No. 98-16

NOTICE

Bravo Drive Shaft Housing Replacement

- a** - Bravo One / Two Standard Insert Location
- b** - Bravo One / Two Optional Insert Location

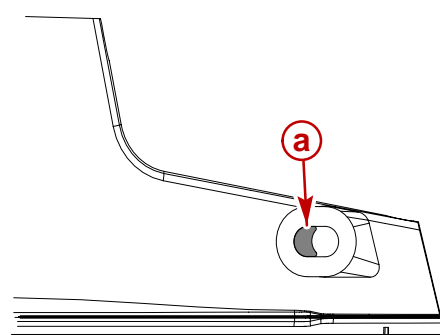
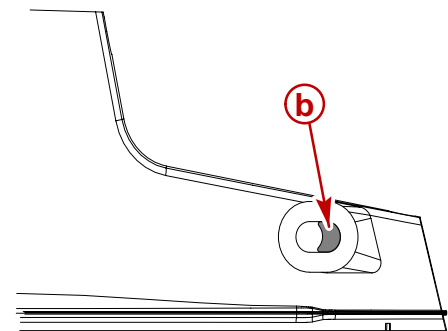
The 1589-8868A25 and 1589-8868A55 drive shaft housings will supersede to the 1589-8868G21 drive shaft housing. The anchor pin hole changes from the round aft anchor pin hole to the elongated (slotted) aft anchor pin hole. The elongated (slotted) aft anchor pin hole requires the use of a crescent shaped insert (808006). This insert is included with the housing to position the pin placement for Bravo One / Two / Three.

For the Bravo One and Two, the insert is placed in the **FORWARD most position** in the aft anchor pin hole. This placement will give the normal minus 5 degrees of trim under. The insert may be placed in the **AFT most position** of the slotted hole to limit the amount of trim under for boat hulls requiring less trim under.

a - Trim-In Limit Spacer Location

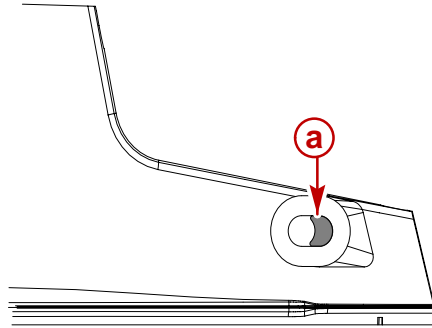
For the Bravo Three drive unit, the insert **MUST BE** placed in the **AFT most position** in the slotted hole to limit the Trim Under.

When the 1589-8868G21 housing is used on a Bravo Three drive unit, the Trim-In Limit Blocks (806692A2) will no longer be required. **DO NOT** reinstall them on the drive unit. If the blocks are already installed, they **MUST BE REMOVED**.

After placing the insert in the AFT most position of the slotted hole, install a Tilt Limit Spacer Kit (15768A3). Use 1 spacer per cylinder as shown below to prevent the bell housing and drive shaft housing from contacting the gimbal ring U-Bolt.
